**WH01 - Replacing Lower Control Arms on the Front Axle (Workshop Campaign)**

Model Line: **Panamera (971)**

Subject: **Lower control arms on the front axle**

*Control arm spoiler mounting*

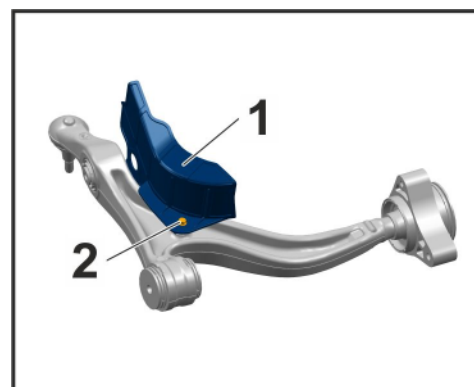
7.2 Remove control arm spoiler at the left and right ⇒ *Control arm spoiler mounting -1-* on the control arms you have just removed.  
To do this, unscrew the fastening screw ⇒ *Control arm spoiler mounting -2-* and remove the control arm spoiler from each control arm.

7.3 Position control arm spoiler ⇒ *Control arm spoiler mounting -1-* on the **new control arm at the left and right** and secure it with the fastening screw ⇒ *Control arm spoiler mounting -2-*.

**Tightening torque 8 Nm (6 ftlb.)**
